Appendix A: Public Comment Notices and Invitation to Participate

Step 2 2028-30 Regional Flexible Funds.

May 2025

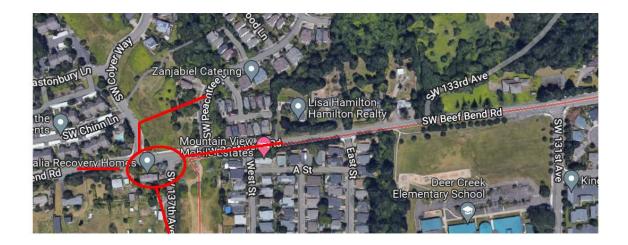
The grant application omits King City's plan to 'stub' the Capulet and Fischer Road extensions, and to not complete the connection with SW 137th Avenue until some time in the future.

Line 41 states " This project includes the street connections from SW Capulet Lane, SW Montague Way, and SW Fischer Rd." King City staff have told the King City City Council, and the community, that the connections to 137th will not be made until the improvements to SW 137th Avenue (to collector status). The improvements to 137th are identified in the King City TSP project list as "Unconstrained Tier 3 -the last phase of projects to be implemented, should additional funding become available."

The Westside Trail Layout (Grant Exhibit A) shows that the extension of SW Montague Way is stubbed. The future connection that is shown is through a park owned by Rivermeade Community Club, a 501(c)(7) organization that is vigorously opposed to King City building a road through their community park.

It is not a responsible use of the grant funds to build roads that will not be connected until some unidentified time, likely many years in the future.

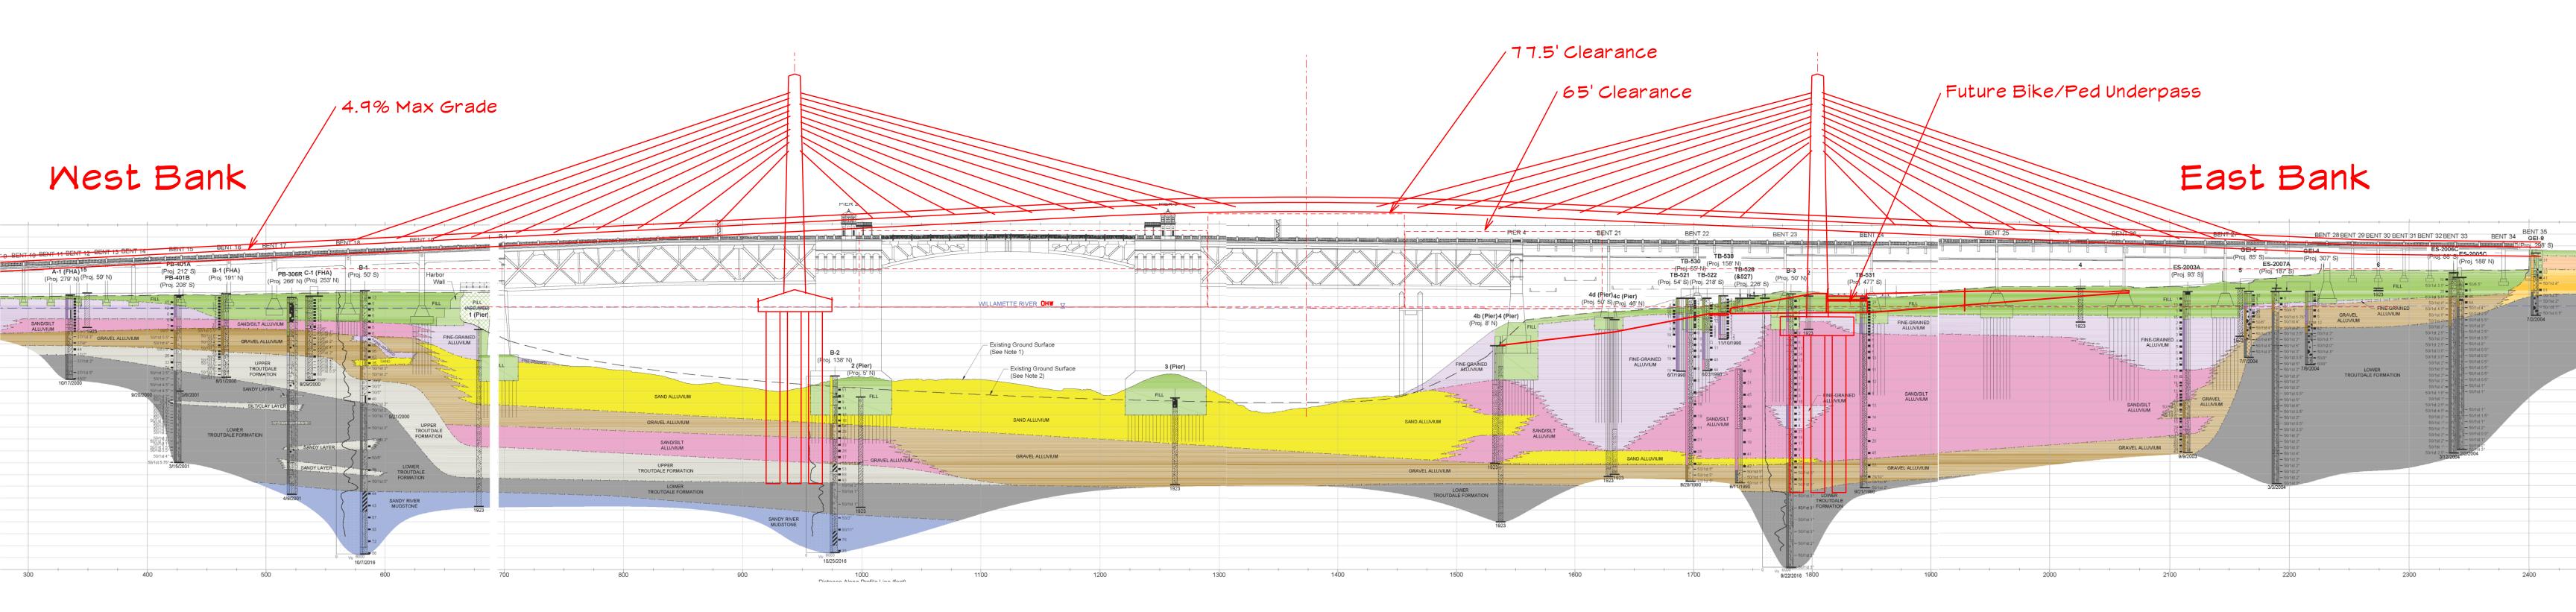
Additionally, the current EQRB fails to connect the Eastside neighborhoods to the eastside river esplanade; a simpler, less expensive bridge must, given the scale of this public investment, include this vital on-grade connection to serve the current and future residents and visitors in the Eastside communities, especially as it grows in population and density.

A fixed span bridge need not require the interruption of the Eastside Esplanade and its floating segments, except for the briefest periods of time, especially if the floating esplanade is fitted with a temporary construction safety roof right under the bridge.

Two Tower Fixed Span Burnside EQRB Alternative

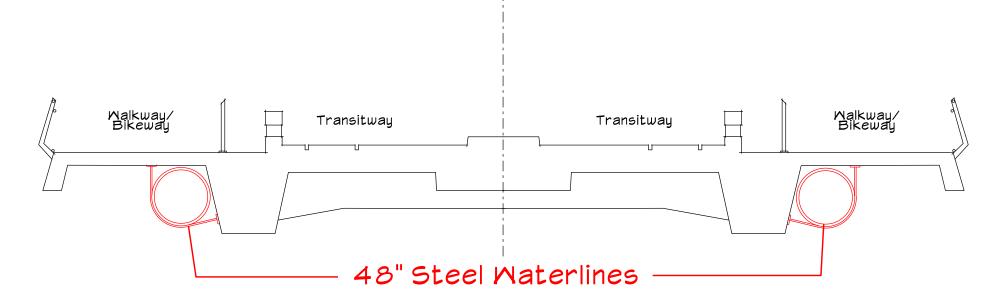
Multnomah County has hired a first-class bridge design team including one of the premier bridge design firms in the world; let them go back and design a beautiful, affordable fixed-span bridge that meets our transportation needs, along with our earthquake-resilient water supply needs and community connectivity needs!
